Work Lead Repositioning

***Field Service Bulletin
803510 - Revision 0***

**Field Service Bulletin
IM-351
(P/N 803510)**

Revision 0 January, 1999

Identify Work Lead and Current Sensor

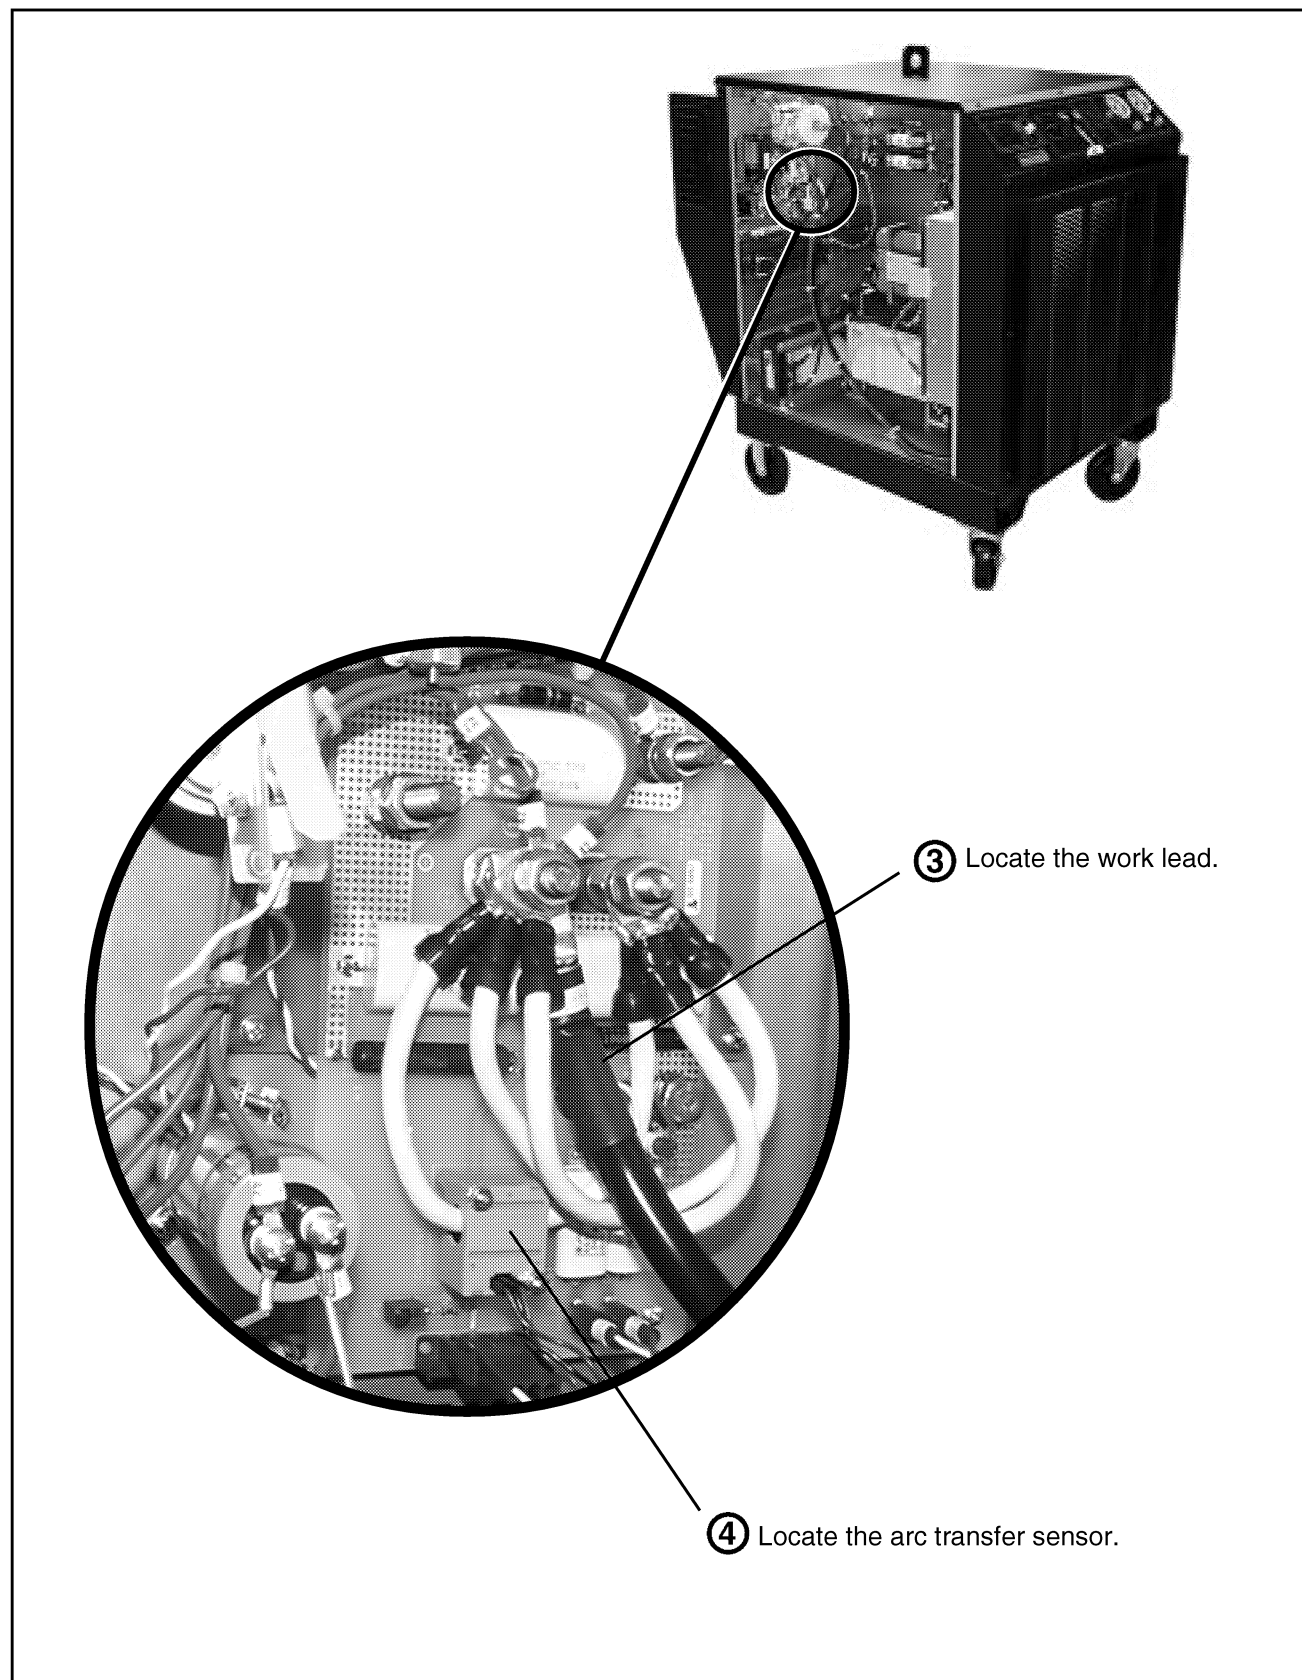
The arc transfer sensor (current sensor) can be influenced by the electric field of the work lead, resulting in a reduction in total output current. If the work lead is routed too close to the current sensor, the 200 amp process may experience decreased output.

This bulletin provides instructions for repositioning the work lead away from the current sensor to alleviate this problem.

Check and Correct Lead-to-Sensor Clearance

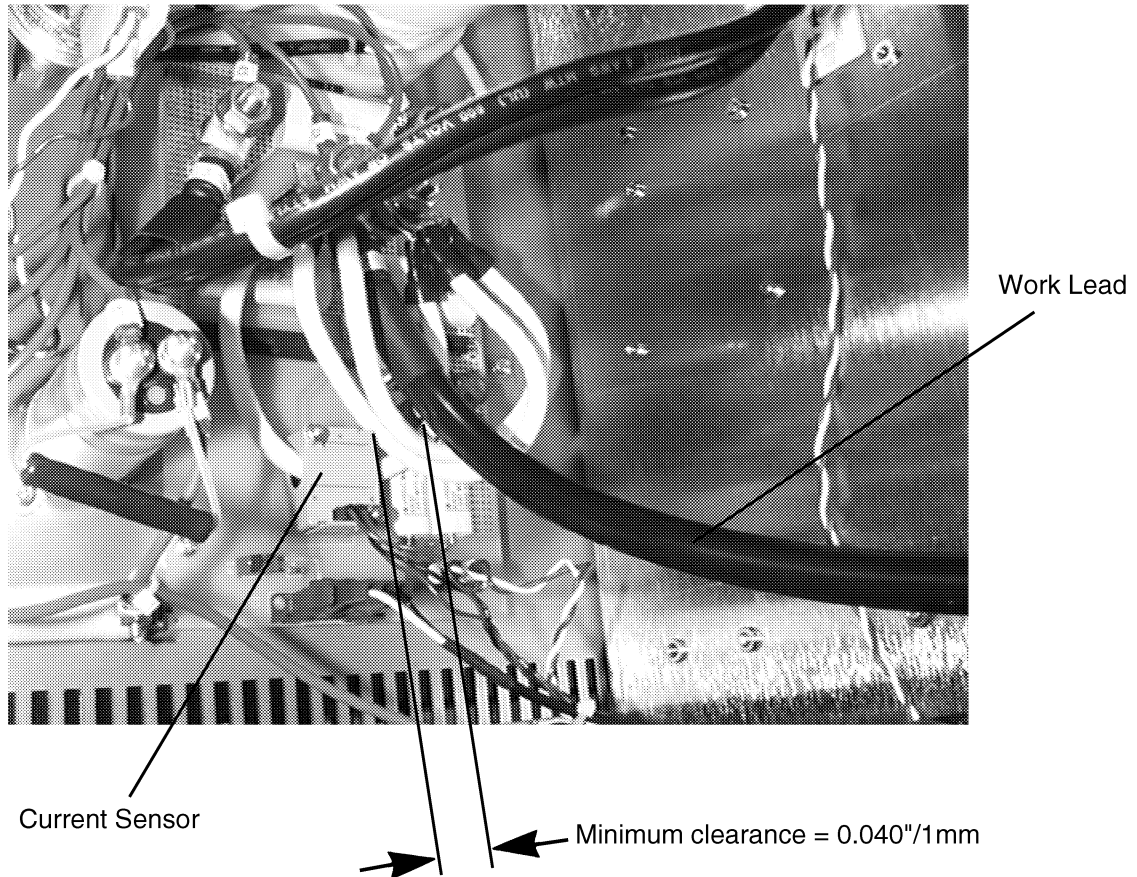
- ⑤ Check clearance between the current sensor and the work lead.

- ⑥ If clearance is less than minimum:

1. Loosen the work lead connection to the PC board (PCB5).
2. Position the lead away from the sensor.
3. Retighten the lead connection.
